Agenda
City of Springboro Planning Commission Meeting
Wednesday, March 8, 2023, 6:00 p.m.
Council Chambers, City Building, 320 West Central Avenue

Site Plan Review, 800 West Central Avenue (SR 73), proposed Sheetz fuel center, convenience store/restaurant

Site Plan Review, 25 West Central Avenue (SR 73), new bank branch for River Valley Credit Union

Concept Elevations

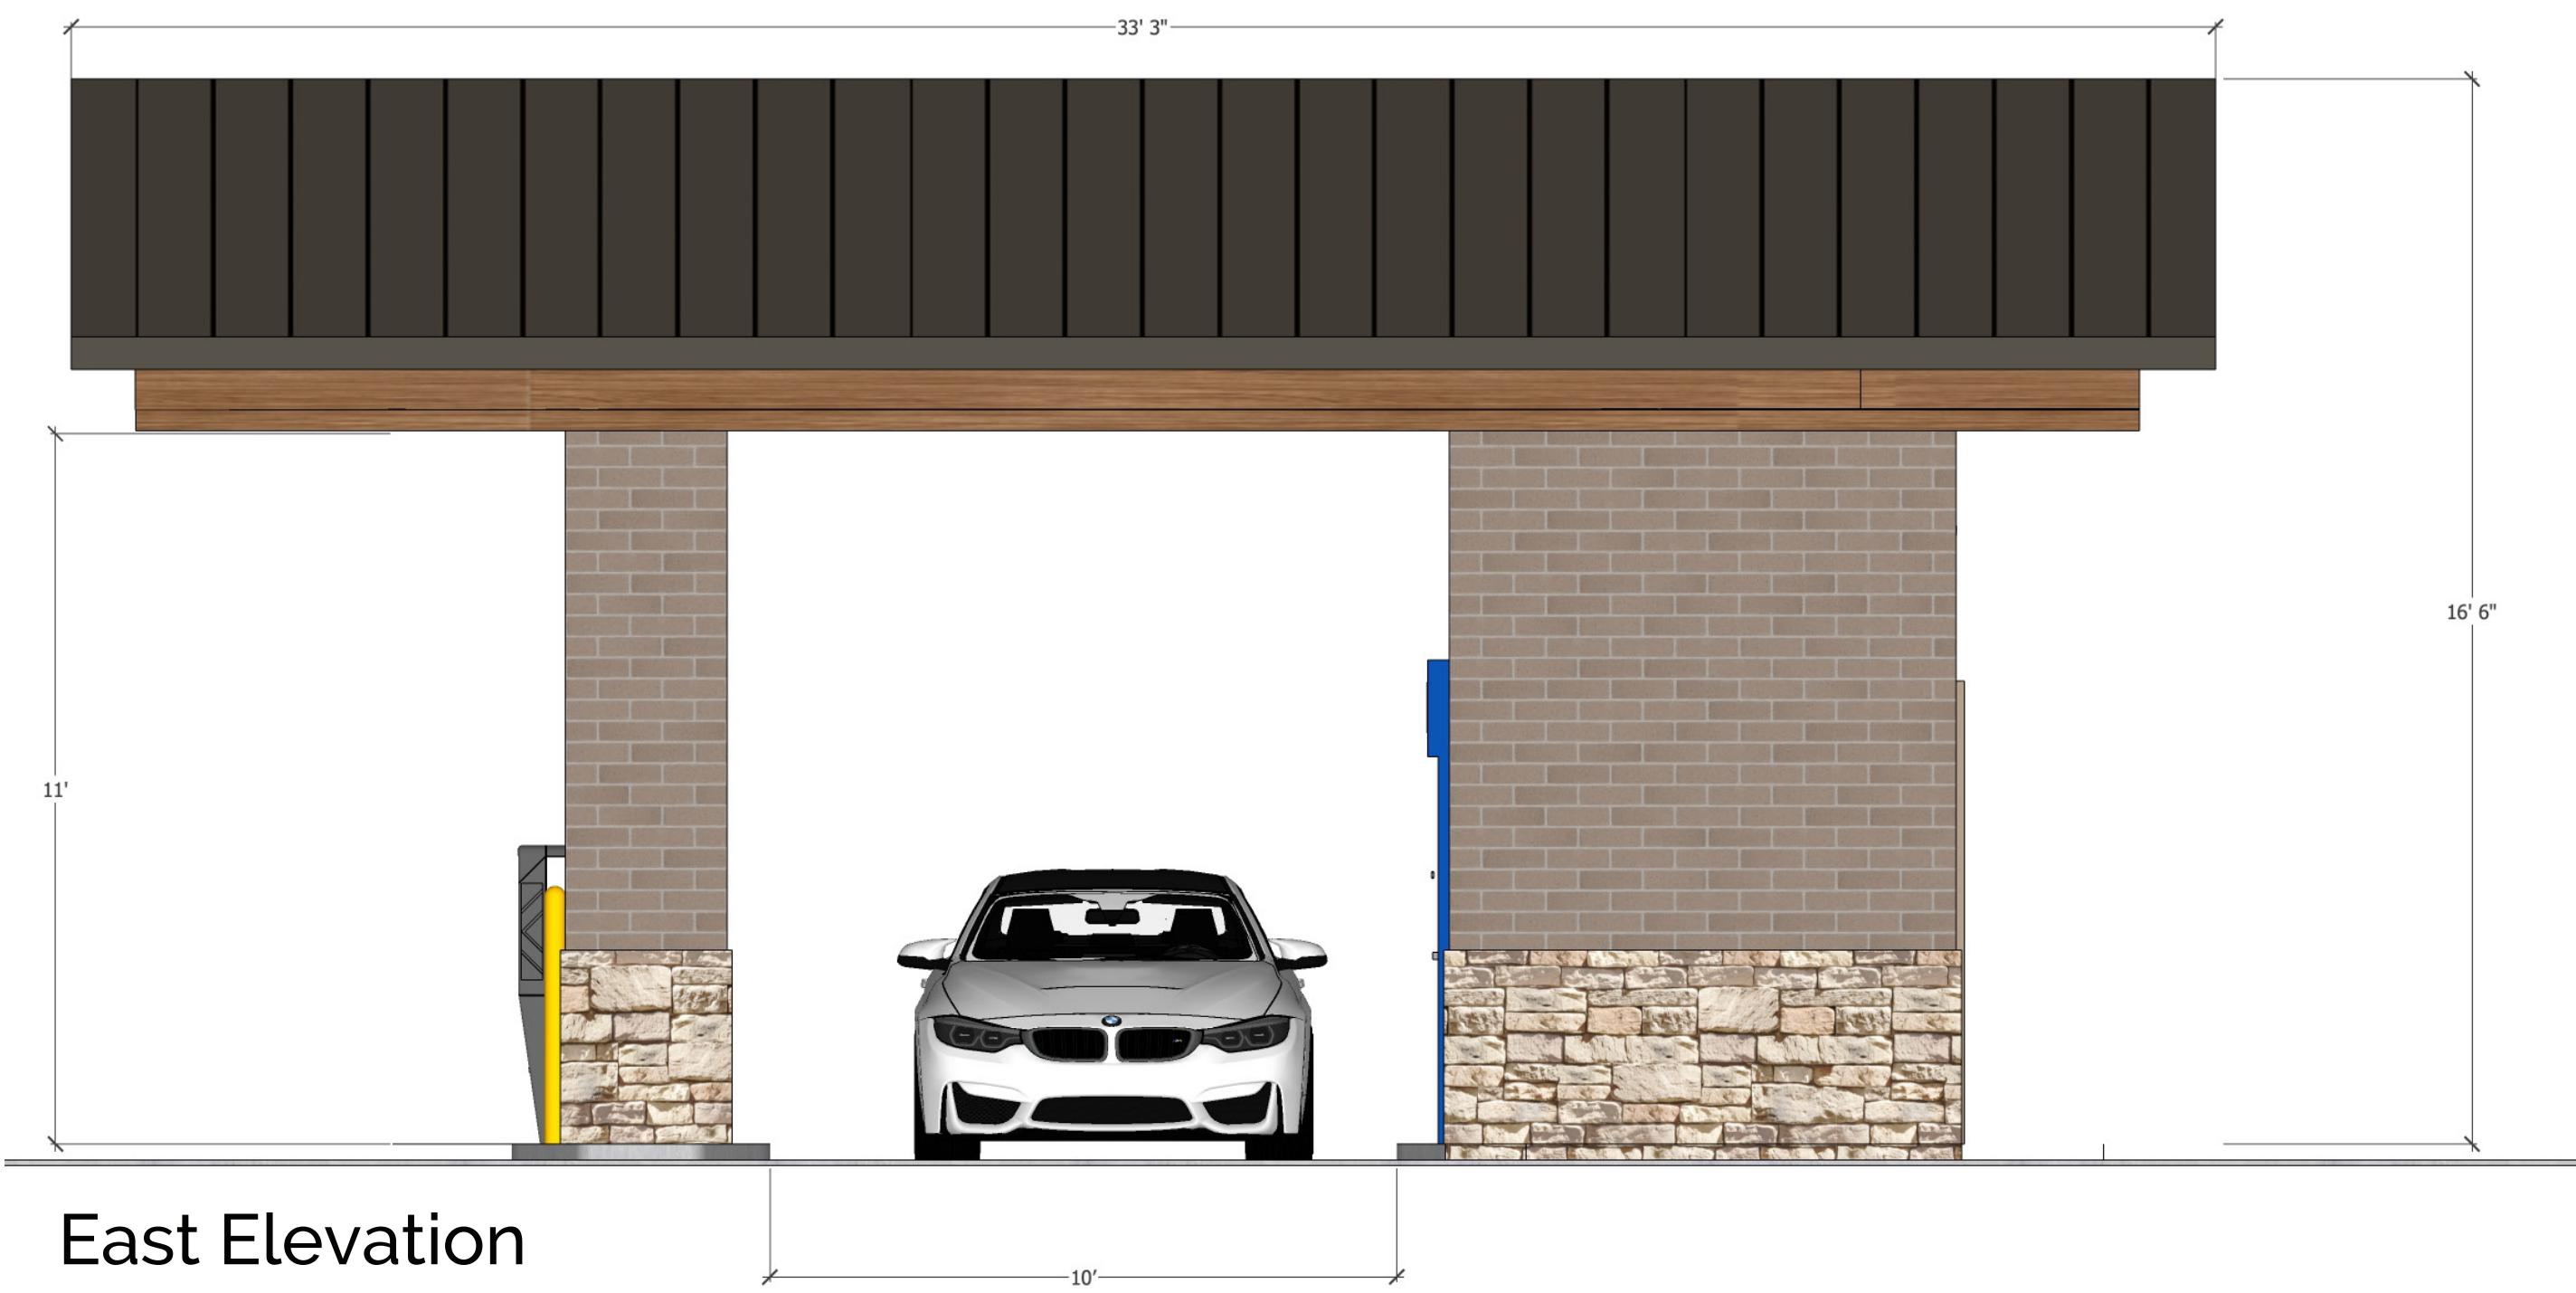
5. Provide dimensions to property line for proposed sign and accessory structure on Florence Drive frontage.
6. Revise east (Florence Drive) and south elevations to meet four-sided architecture requirement. See UVD Section 1267.08(a)(1) (typical citation through comment #13), and orientation to street requirements. Section 1267.08(a)(2).

7. Windows on east elevation to meet vertical orientation requirement. Section 1267.08(a)(3). Also verify all glass to meet material requirements. Section 1267.08(a)(4).

9. North (West Central Avenue) and east (Florence Drive) elevations to meet 65% opacity requirement. Section 1267.08(a)(10).
10. Landscaping to be reviewed following preliminary review of site plan in light of Section 1267.09 and Chapter 1279, Landscaping.
